Planning and Zoning Commission

October 6, 2020

TO: Planning and Zoning Commission
FROM: Evann Martin, Assistant Planner
DATE: October 6, 2020
RE: Destination Market Plat 5 – Preliminary Plat

RE: Destination Market Plat 5 Lot 1 Coffee Shop – Site Plan

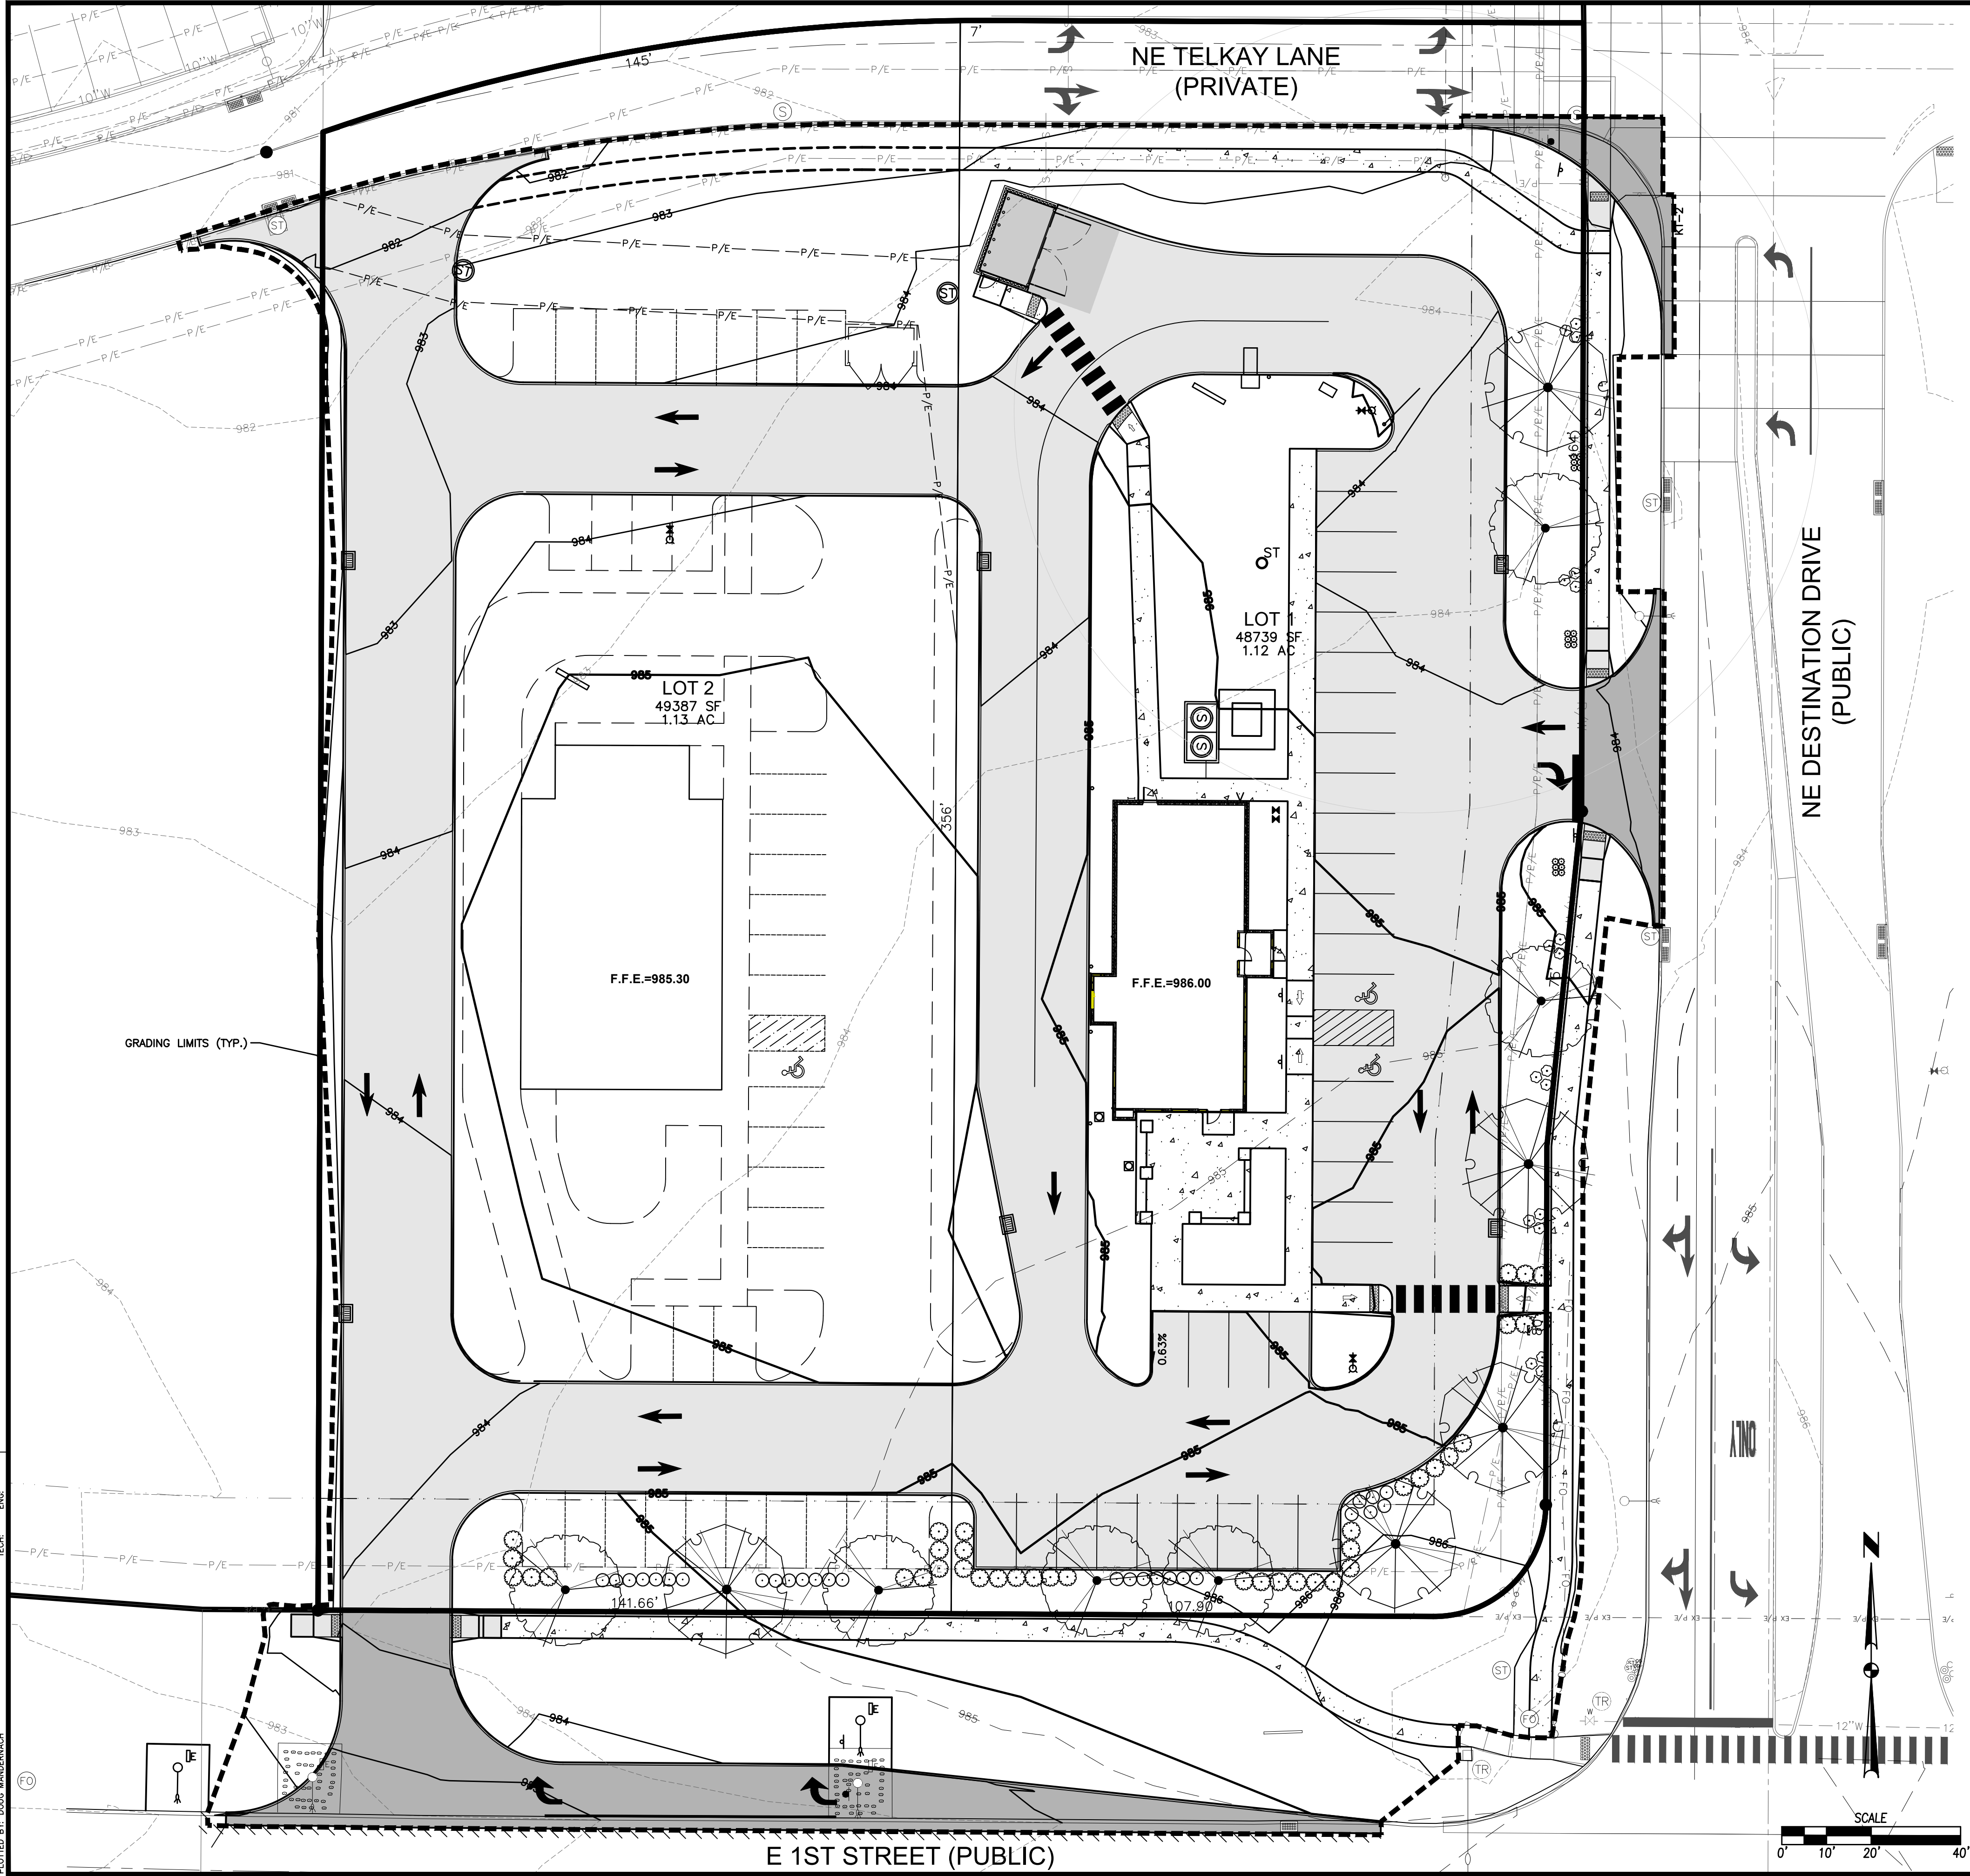
- ~~1. Please provide a separate preliminary plat document with sheets for lot layout, grading, utilities, public improvements and concept plan.~~
- ~~2. Please provide a concept plan for both lots with location of landscape buffers shown.~~
- ~~3. Please provide information as listed on the preliminary plat application.~~
4. Label dimension of south property line of Lot 1 and 2.

DESTINATION MARKET PLAT 5
DIMENSION PLAN

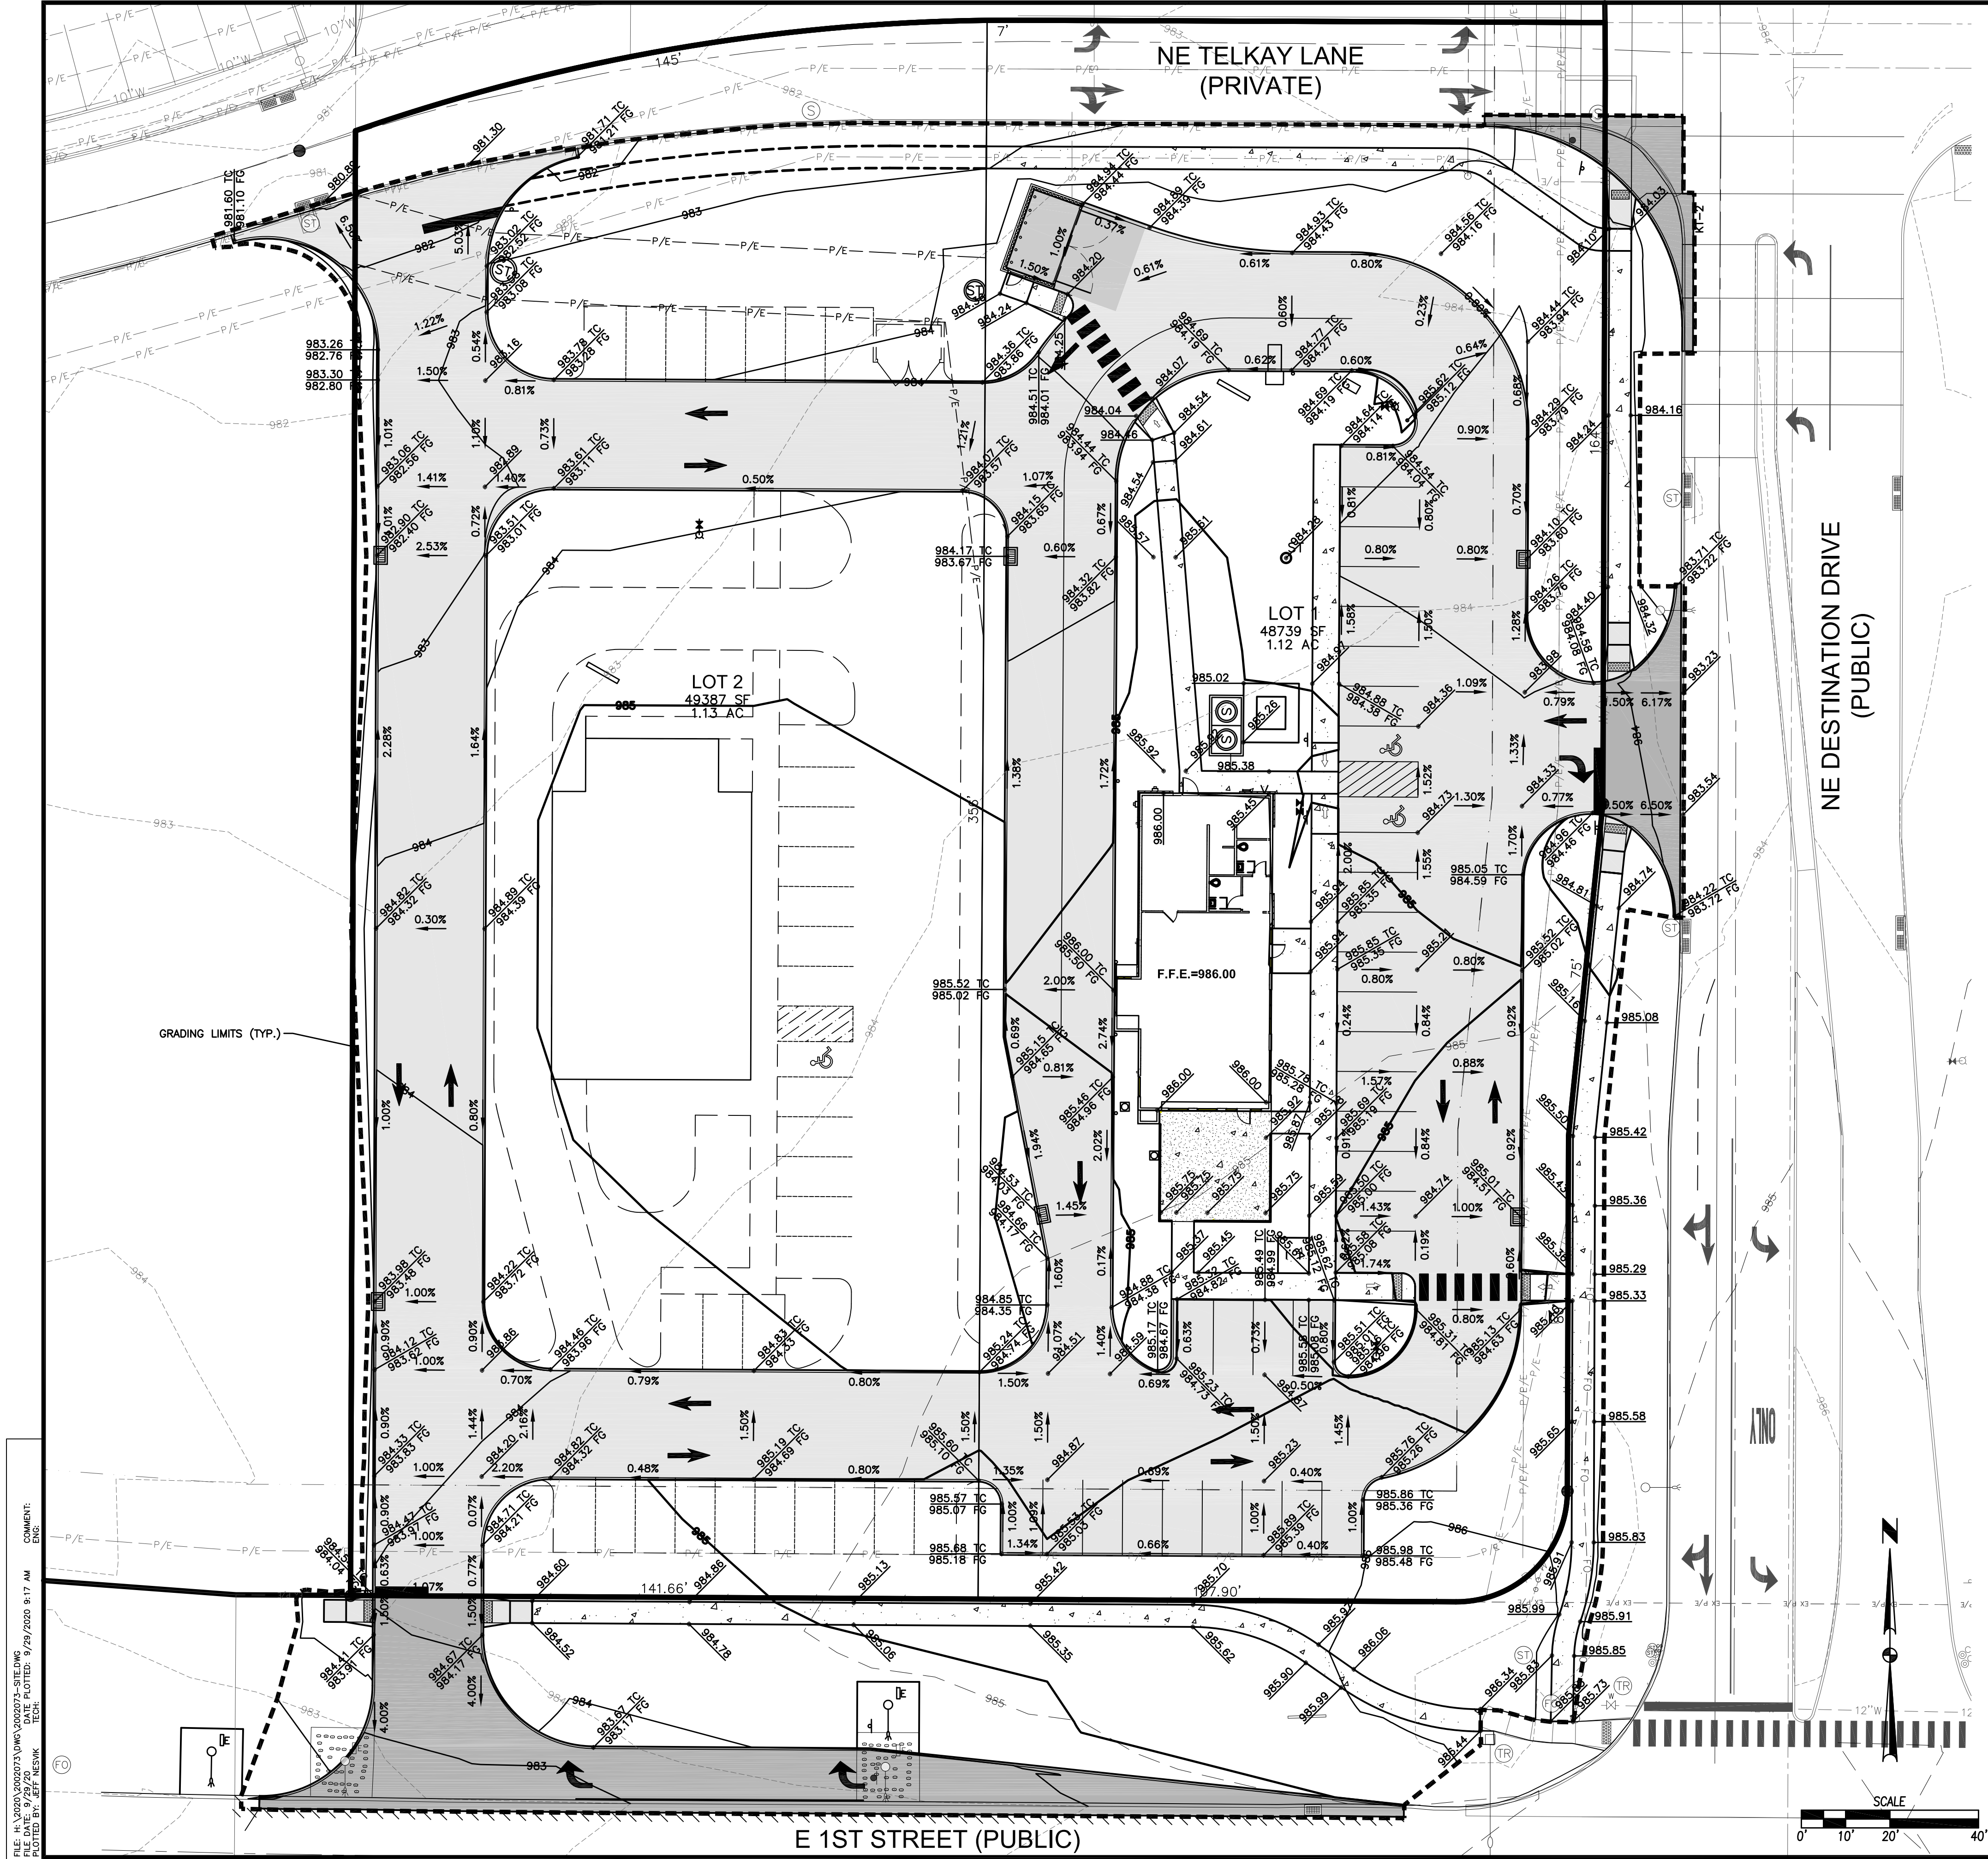
1. ~~Add 8" thickness for ROW pavement in Destination ROW.~~
2. ~~Add city standard notes for site plans (12/26/19).~~
3. ~~Can driveway on Telkay be aligned with existing driveway to the north?~~

4. ~~Staff is concerned with the circulation of the site and will need to review the concept plan for Lot 2 to better understand the situation. Staff may have future comments. Based on the concept plan shared during the meeting on 9/9/20, staff has the following comments, concerns, suggestions:~~

- b. ~~There needs to be a median to separate the drive thru lane from the north/south drive aisle.~~
 - c. ~~Can the drive aisle along the west property line be shifted to be shared with the property to the west? We would still want to try to align the driveway with the Menards. A shared drive could provide more room to install a median and allow for vehicles to turn west out of the drive thru lane. Otherwise, the drive aisle needs to be 5' from the property line.~~

- e. ~~Overall, the site seems small for a restaurant use especially with a drive thru and the need to provide the drive aisle to Telkay. Parking for restaurant users will need to provide 10 spaces per 1000 sf GFA plus 5 drive thru stacking spaces. 15% open space is required.~~

5. ~~Add stop bar pavement marking on east driveway onto NE Destination.~~
6. ~~Provide stop sign locations. Add stop sign locations on E 1st St and Telkay.~~

7. ~~Provide 5' sidewalk along north property line.~~
